Site Accessibility Evaluation

DOT Calhan Office

**1010 Golden St
Calhan, CO 80808**

Inspection Date: 08/23/2019

Finding 297746 Main Photo

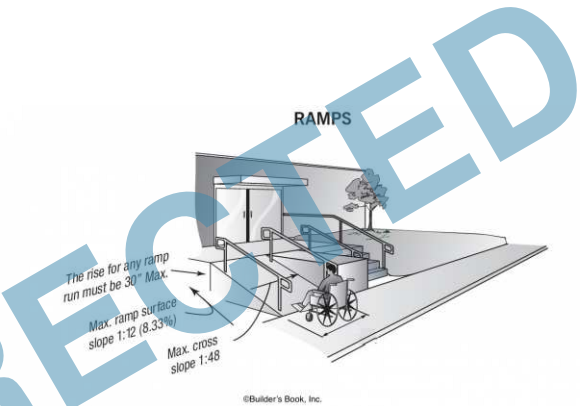
Finding: 1

The ramps slope exceeds the maximum running slope (direction of travel) allowable of 8.33%.

Ramps should have the least possible slope but in no case more than 8.3% (1:12).

2010 ADAS Section 405.2

Ramp runs shall have a running slope not steeper than 1:12.

19.20 % running slope

Create new concrete ramp and remove existing detachable metal ramp. New ramp at 4 feet in length would meet ada compliance at 8.33%.
